**ADDENDUM NUMBER ONE TO PLANS AND SPECIFICATIONS FOR  
2022 HVAC RENOVATION FOR  
RAINS JUNIOR HIGH SCHOOL  
RAINS INDEPENDENT SCHOOL DISTRICT**

**ENGINEER: EMA ENGINEERING & CONSULTING  
328 South Broadway  
Tyler, Texas 75702**

02/08/2022

MECHANICAL/ELECTRICAL/  
PLUMBING  
DEMOLITION  
FLOOR PLAN  
AREA C  
SHEET NUMBER

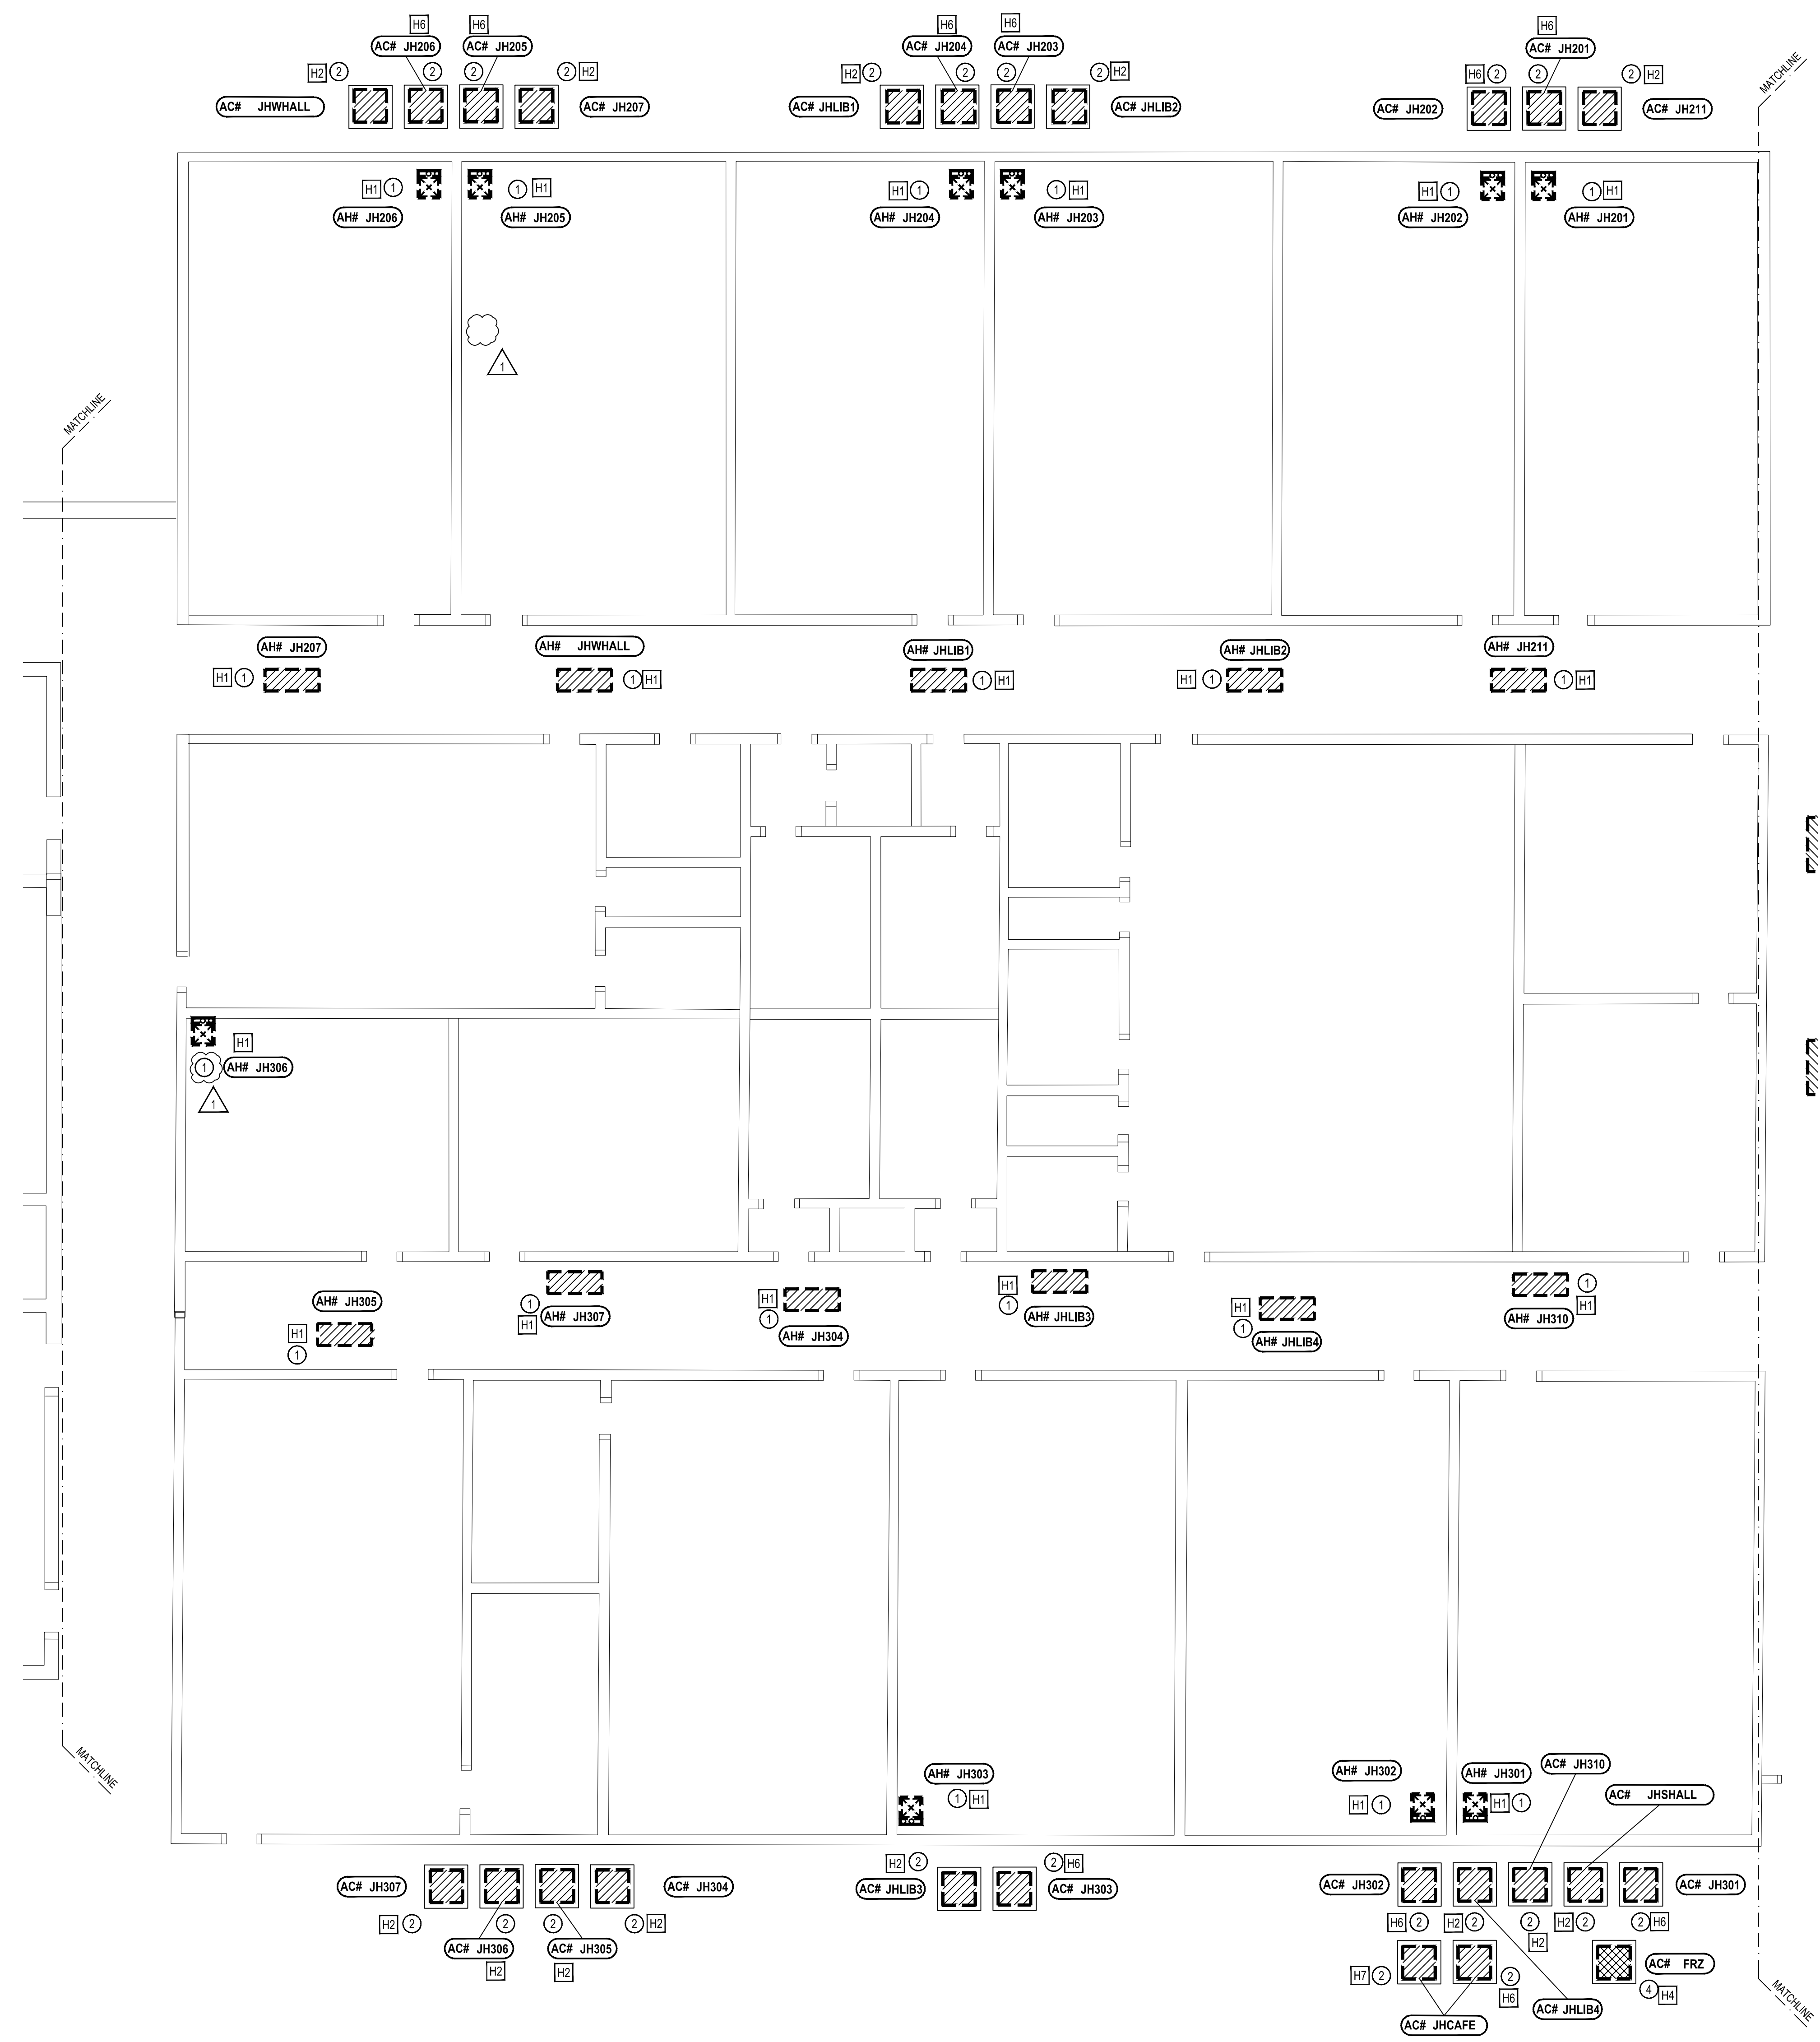
**SHEET MEPD1.3**

A. Refer to the attached sheet for plan note location corrections.

MECHANICAL/ELECTRICAL/  
PLUMBING  
DEMOLITION  
FLOOR PLAN  
VOCATIONAL AG  
SHEET NUMBER

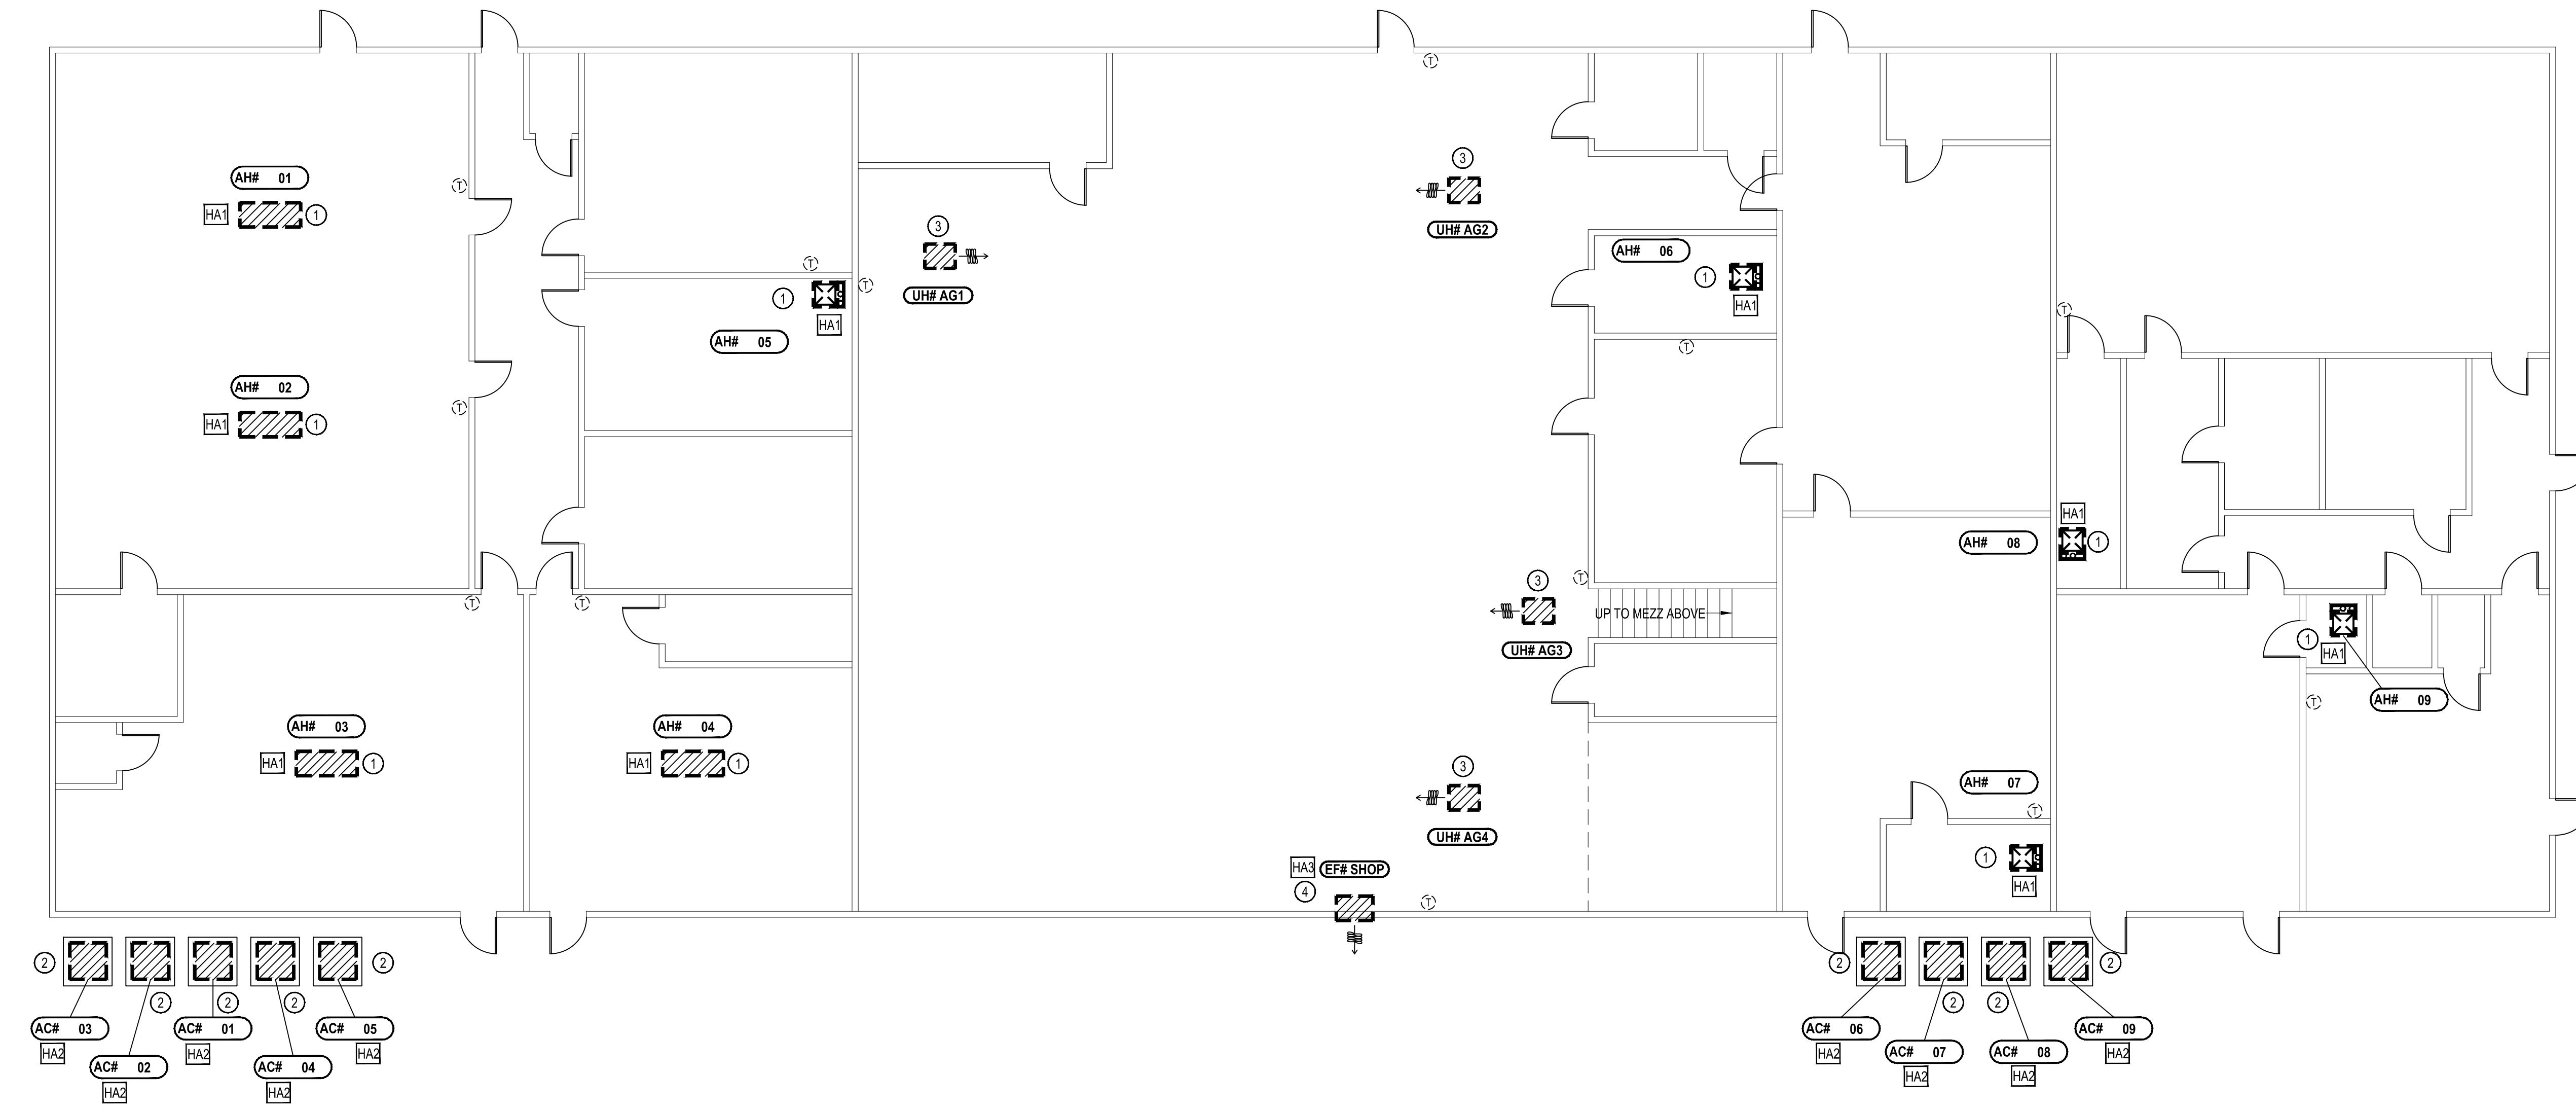
**SHEET MEPD1.7**

A. Refer to the attached sheet for the Vocational Ag building demolition plans.

SHEET NUMBER  
**MEP1.1**

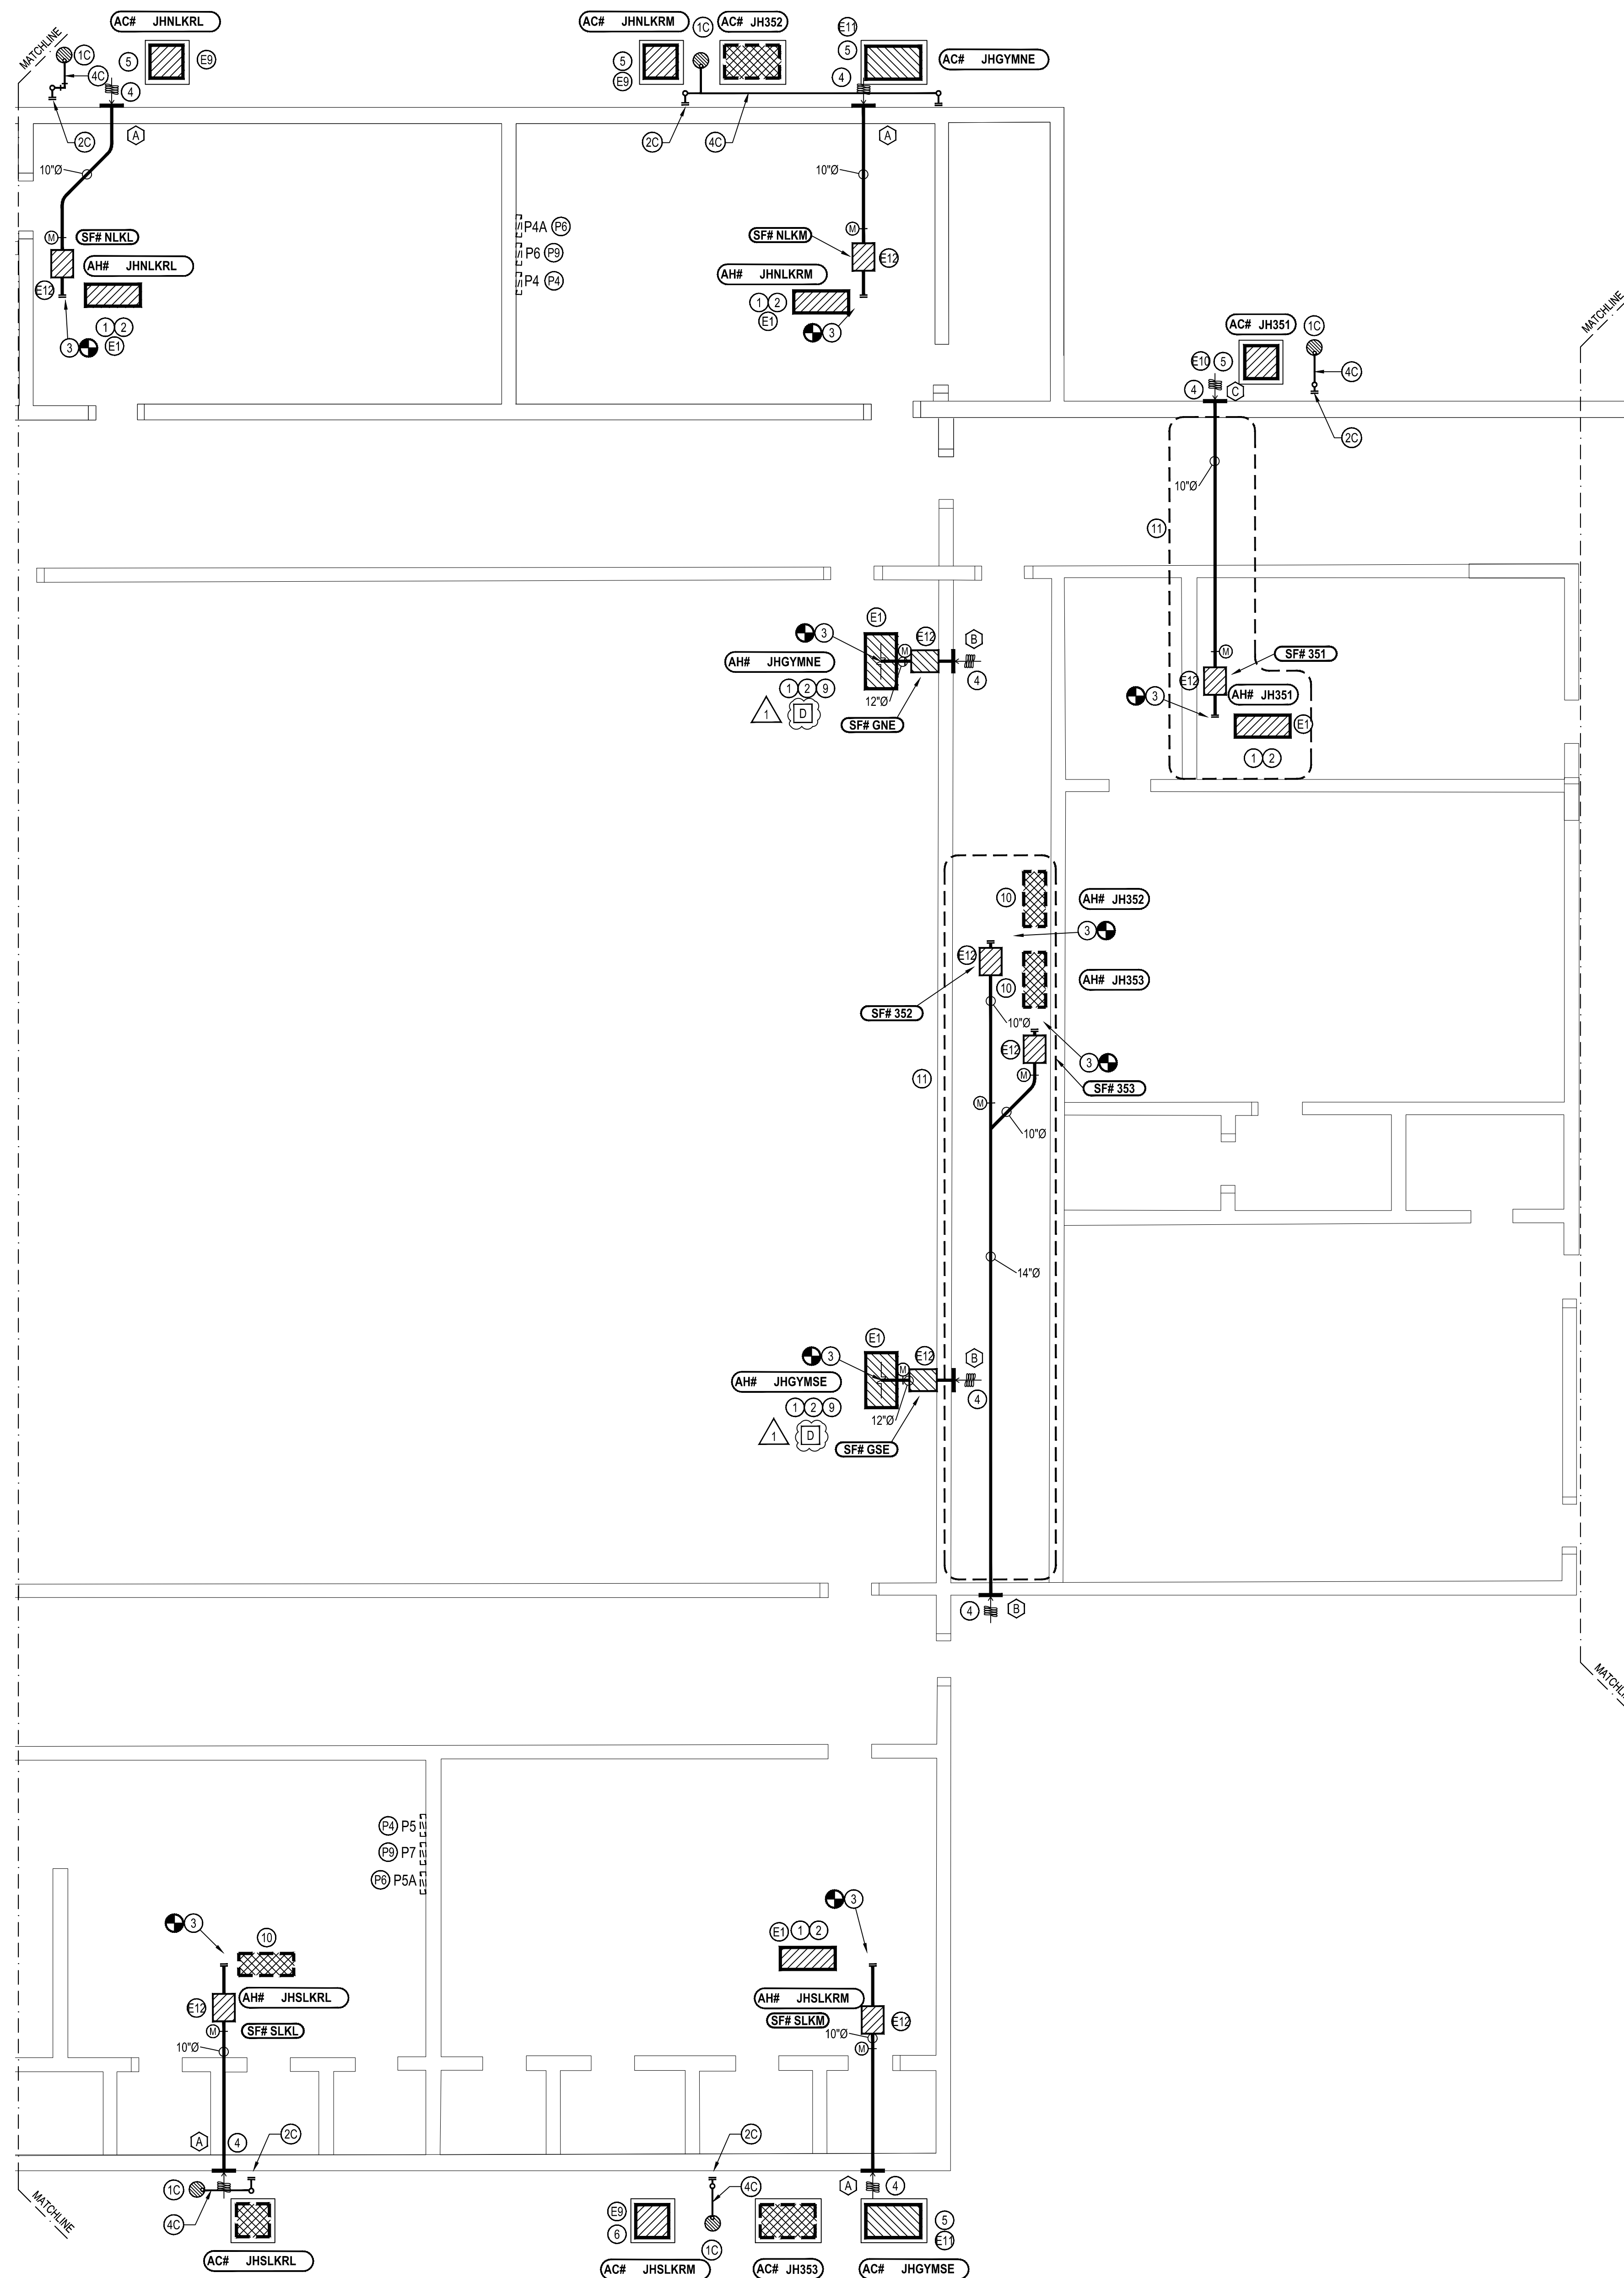
**SHEET MEP1.1**

A. Refer to the attached sheet for added duct detector notation.
